EMLA-2021-BF144-02-001

July 23, 2021

Subject: Response to Notice of Disapproval, Completion Report for Regional Aquifer Well R-70, Revision 1, and the Response to the New Mexico Environment Department's Draft Comments on the Completion Report for Regional Aquifer Well R-70

Responses to Specific Comments from the Notice of Disapproval, Completion Report for Regional Aquifer Well R-70, Revision 1, and the Response to the New Mexico Environment Department's Draft Comments on the Completion Report for Regional Aquifer Well R-70, Los Alamos National Laboratory, EPA ID#NM0890010515, HWB-LANL-19-080, Dated May 25, 2021

Figure 3.2-1 Monitoring well R-70 as-built construction diagram and technical well completion details

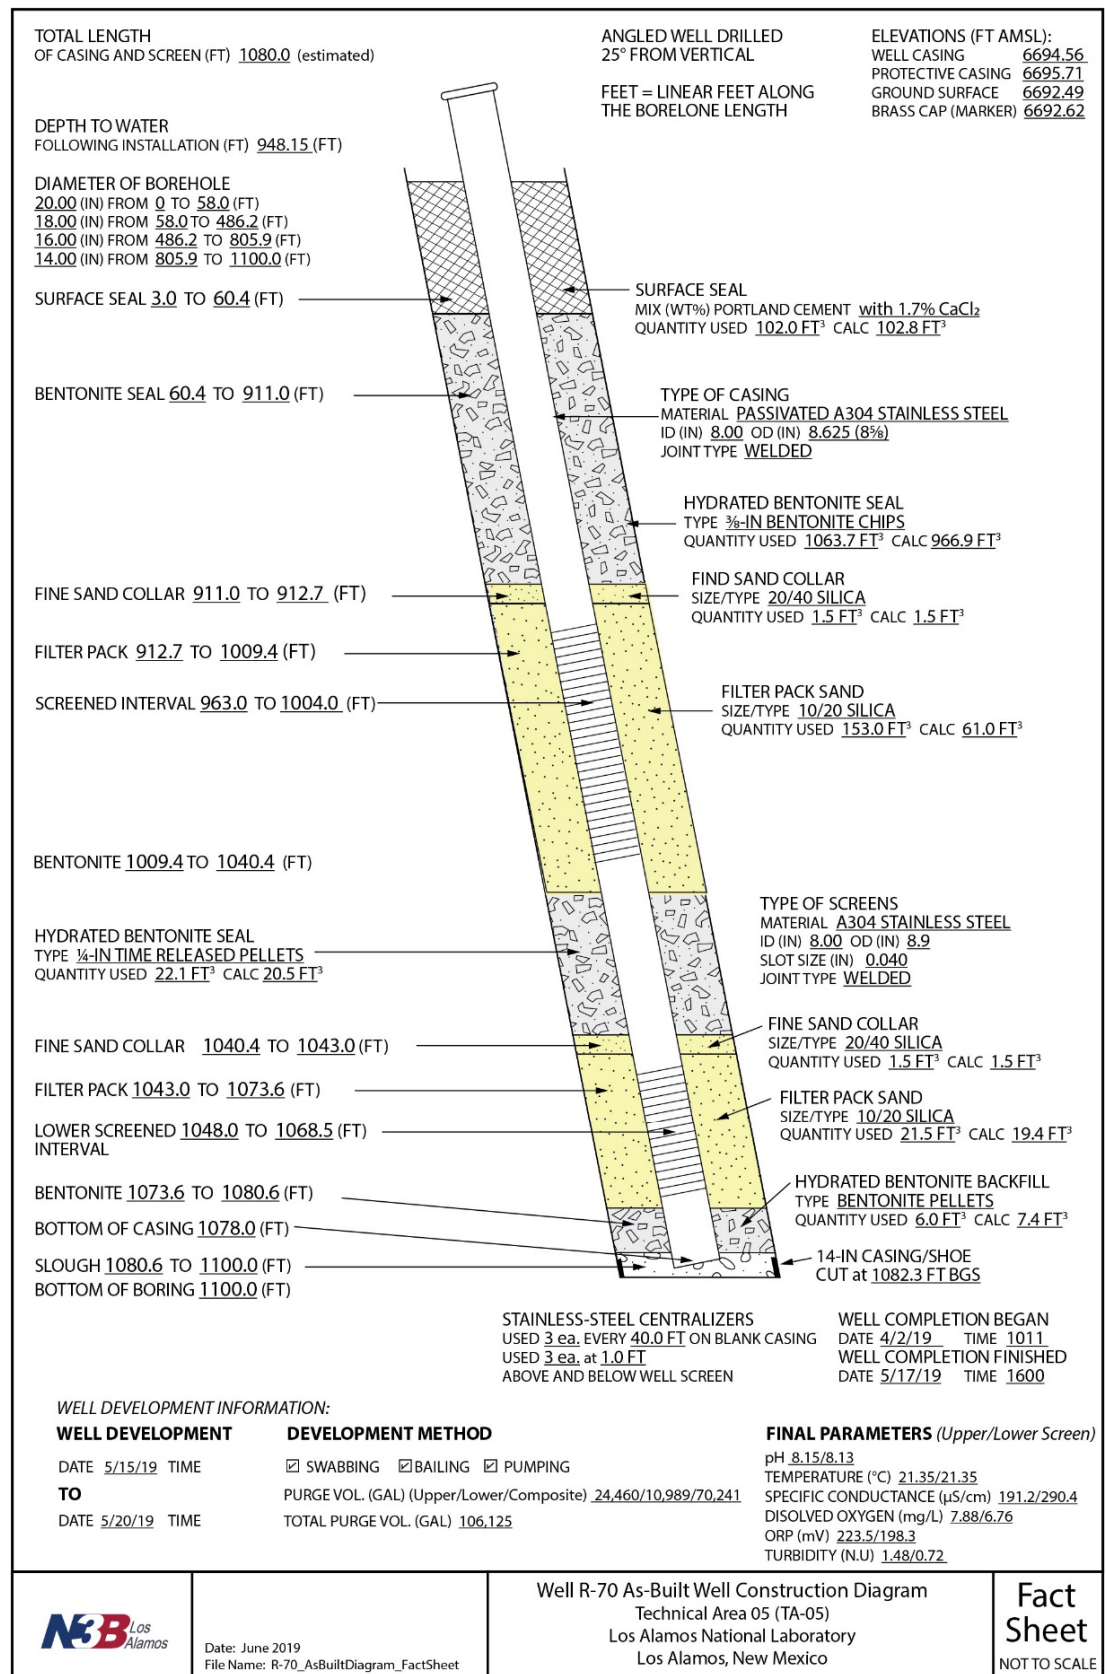
- c. *Revise Figure 3.2-1 Monitoring well R-70 as-built construction diagram and technical well completion details to include well development, final parameter and well survey information like Figure 7.2-1 for R-61.*

- d. *Correct the different pattern used for the top filter pack to be the same as the bottom filter pack, the legend and Figure 3.2-1, if both screens have the same 10/20 gradation filter pack. Likewise, correct the pattern for the transition sand to match with that shown in the legend and Figure 3.2-1.*

4. DOE has made the required changes. See revised Figures 3.2-1, 8.3-1a, and 8.3-1b.

Figure 8.3.1a Installation and construction details for the R-70 sampling system

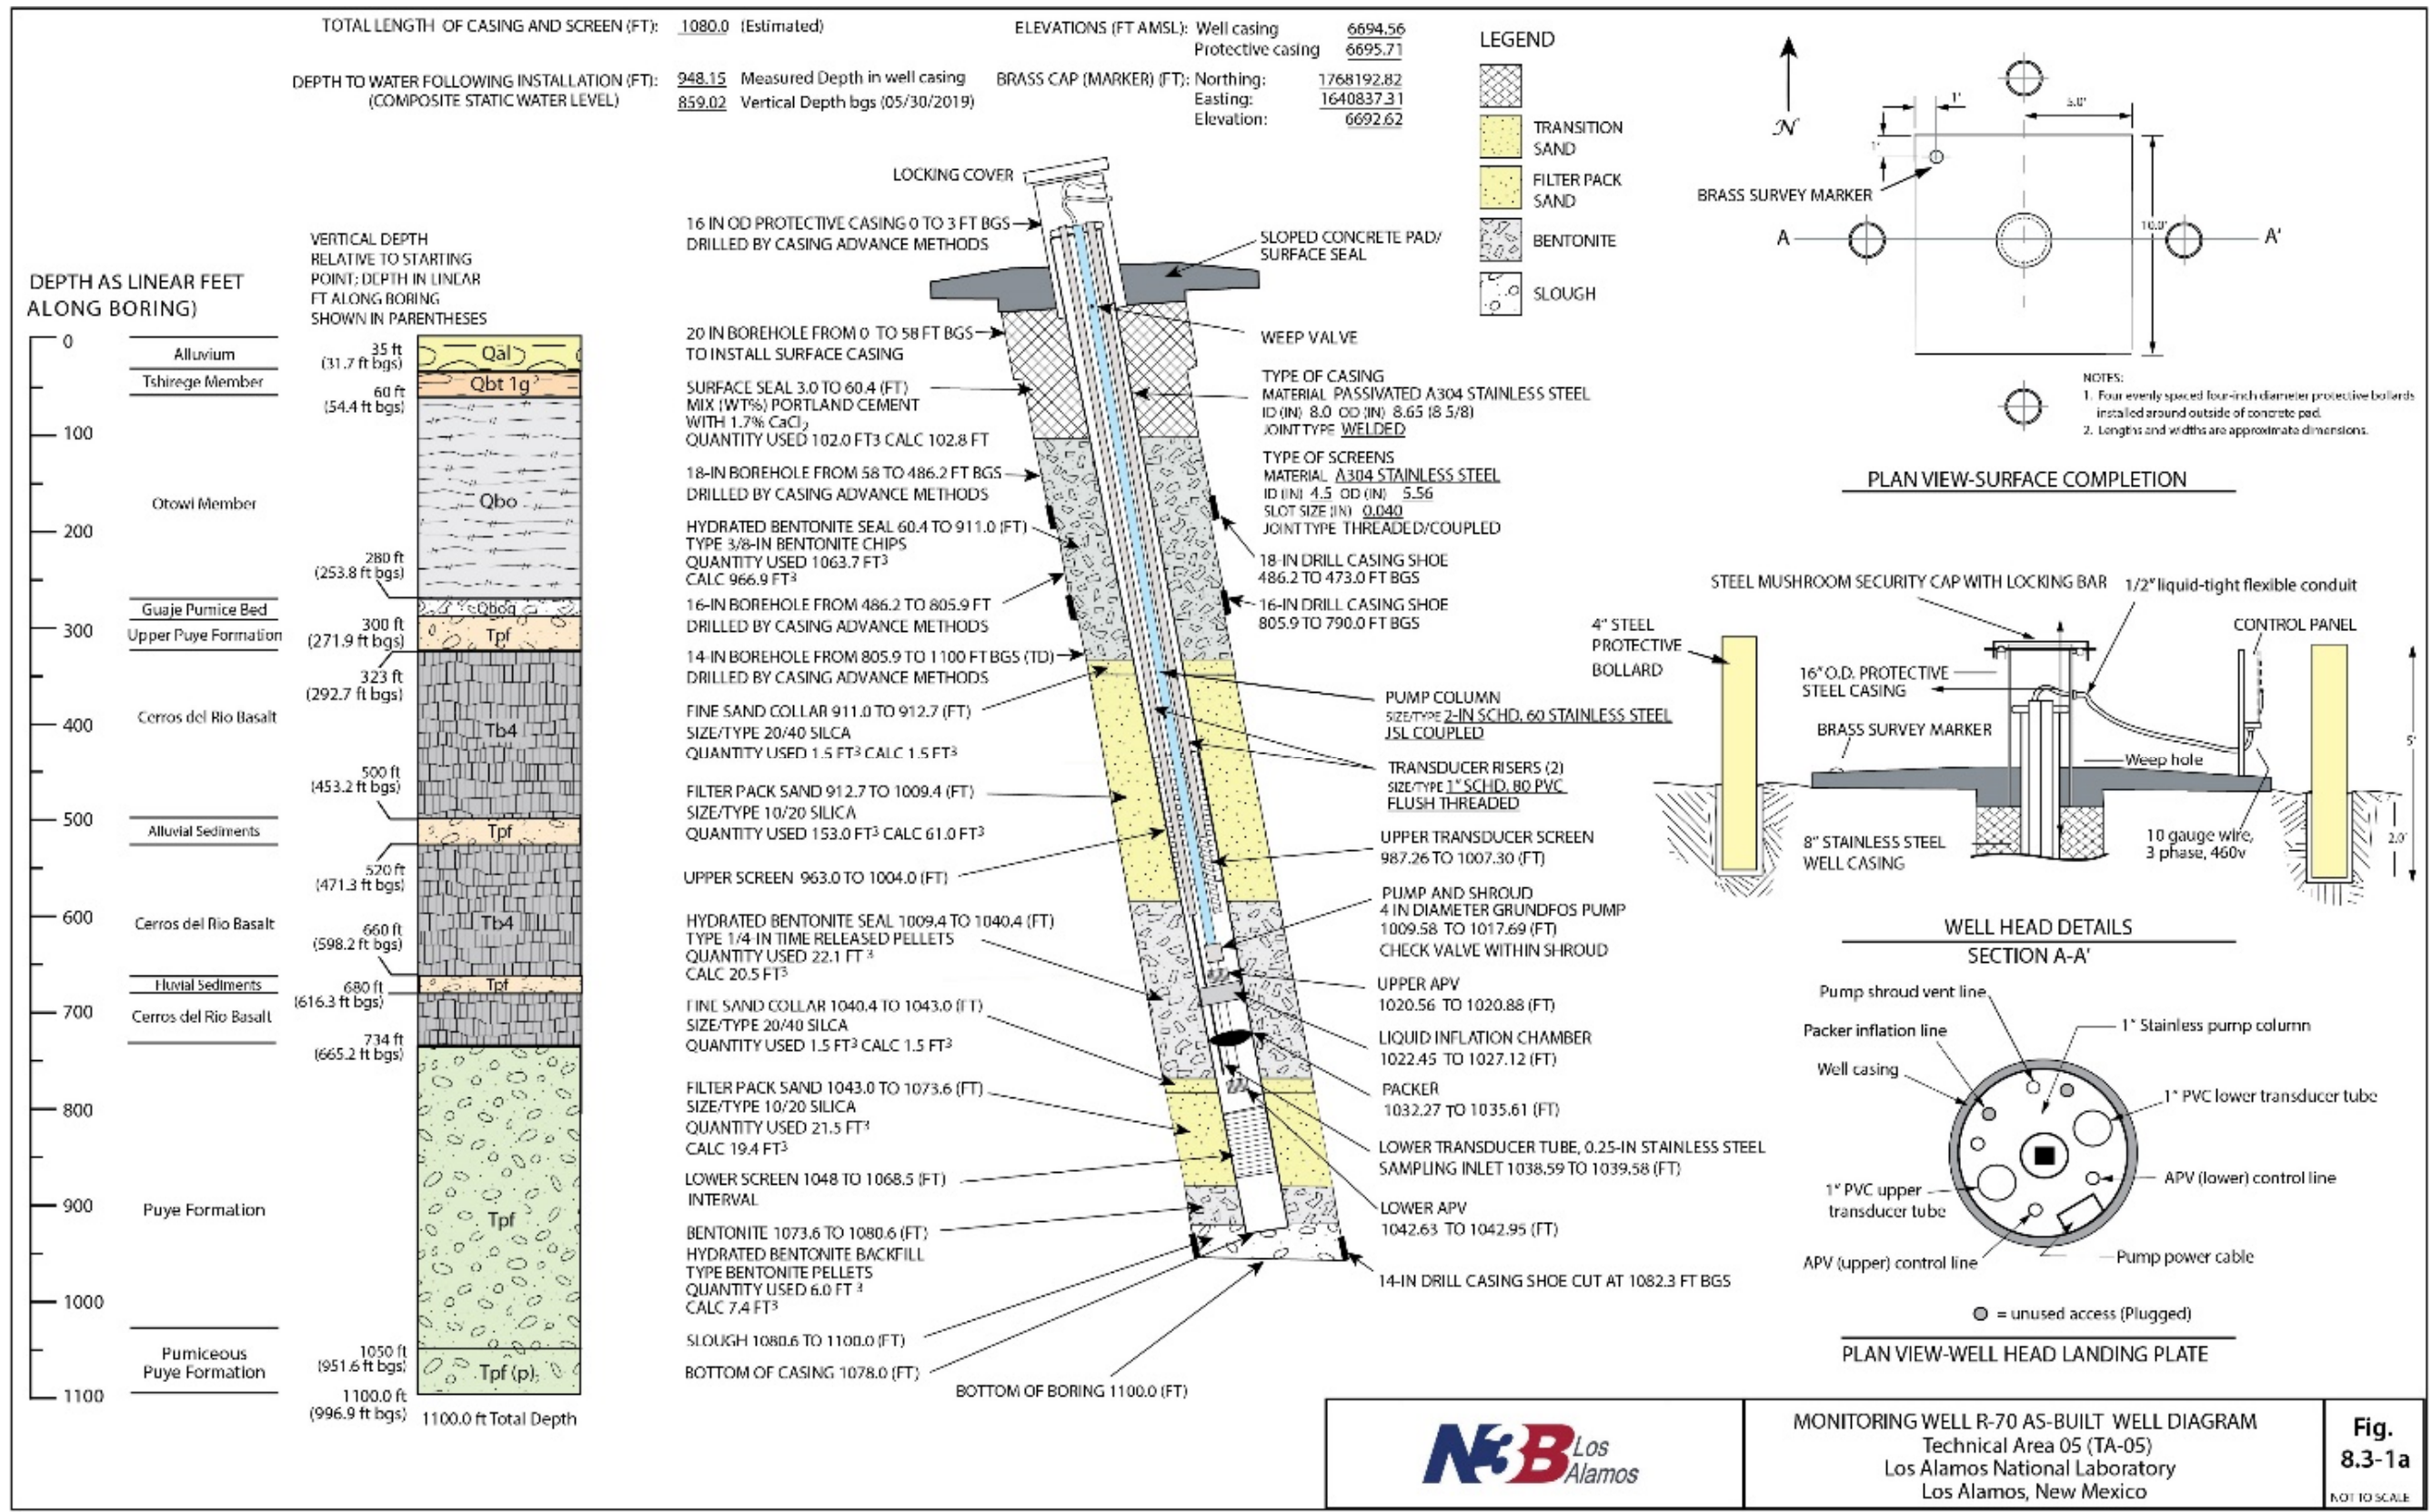
4. Section 8.1.1, Well Development Field Parameters, page 11/Figure 8.3-1a – Installation and construction details for the R-70 sampling system, page 21.

- a. *Based on the most recent Well Completion Details, the following are missing and need to be included in the well completion details for R-70 (Figure 8.3-1a) In a second revision of the Report:*
 - i. Pad
 - ii. Transducer sleeves and description
 - iii. Borehole diameter and description
 - iv. Pump location and description
 - v. Check valve location
 - vi. Pump column and description
 - vii. Casing string shoe locations
- b. *Revise Figure 8.3-1a for to be similar to previous regional aquifer monitoring wells mentioned above. Figure 8.3-1a in the Revised Report lacks the graphical clarity and details and well completion information provided in other dual screen chromium monitoring wells (i.e., R-43*

through R-45, R-50, R-61) and in the most recent monitoring well (R-69), which provide far better understanding of the well construction, completion and Baski sampler set up. NMED would like to emphasize to DOE the importance of well construction as-built diagrams as technical references in future decision making and public review. For instance, in the current figure, the symbols for the surface seal and the bentonite appear in the background of the well casing area obscuring necessary details. Also, the transducer tubes and pump column for R-70 need to be drafted in a manner that is well-defined and clear like those of the other well completion details.

- e. *Correct "Filter Rack" to read "Filter Pack" in the diagram annotations and make the descriptions in the figure on page 21 match the descriptions provided in the text on page 11. Provide better quality assurance and quality control on this and all figures submitted to NMED.*

- f. *Label the features shown in the as-built well diagram within the lower filter pack below the "lower transducer screen" as requested. It is not clear what these features are and how they relate to the other dedicated well components. Please label these features and make the well completion details in the as-built diagram clearer and readily understandable as in the previous chromium group monitoring wells. Revise Figure 8.3-1b to include and explain these features.*

- g. *Indicate where the lower screen transducer tube port is in the well head plan view in the pending revision of this figure.*
